Access Compliance Report

Public Rights-of-Way

(Curb Ramps)

Intersection ID: 53713	Main Street: N_TRYON_ST	Cross Street: PERIWINKLE_HILL_AV	Location: E
ADA ID: D2B83D98CDC1	Ramp Type: Perp	Initial Pass/Fail: Fail	Overall Compliance: No
Severity Score: 8.75			
Codes/Mitigation Info/Possible Solution		Field Measurements/Component Compliance

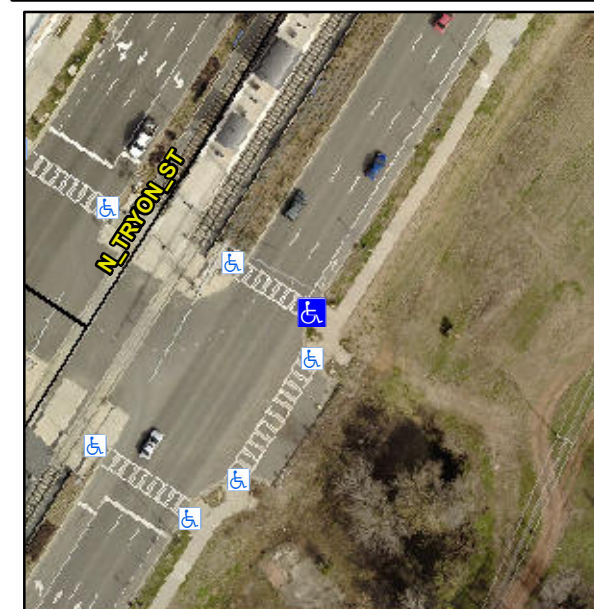
R304.5.1

Compliance	Description	Data	Compliance	Description	Data
N/A	Ramp Length (in)	96.0	Yes	Ramp Slope (%)	6.0
No	Ramp Width (in)	47.0	Yes	Ramp XSlope (%)	0.5
N/A	Flare Type LT	N/A	N/A	Flare Type RT	N/A
N/A	Flare Slope LT (%)	N/A	N/A	Flare Slope RT (%)	N/A
N/A	Flare Traversable LT?	N/A	N/A	Flare Traversable RT?	N/A
N/A	Landing Length (in)	N/A	N/A	DWS Provided?	N/A
N/A	Landing Width (in)	N/A	N/A	DWS Contrast?	N/A
N/A	Landing Slope (%)	N/A	N/A	DWS Length (in)	N/A
N/A	Landing X Slope (%)	N/A	N/A	DWS Full Width?	N/A
N/A	Landing Curb? (Y/N)	N/A	N/A	DWS Offset (in)	N/A
N/A	Shared Landing?	N/A			
N/A	Gutter Ponding?	N/A	N/A	Gutter Slope (%)	N/A
N/A	Gutter Lip Ht (in)	N/A	N/A	Gutter X Slope (%)	N/A
N/A	Painted X Walk1?	Yes	N/A	Painted X Walk2?	N/A
	X Walk 1 Direction	To NW		X Walk 2 Direction	N/A
N/A	X Walk 1 Width (in)	106.0	N/A	X Walk 2 Width (in)	N/A
	X Walk 1 Slope (%)	2.9		X Walk 2 Slope (%)	N/A
	X Walk 1 X Slope (%)	0.7		X Walk 2 X Slope (%)	N/A

Remove & Replace Entire Ramp.
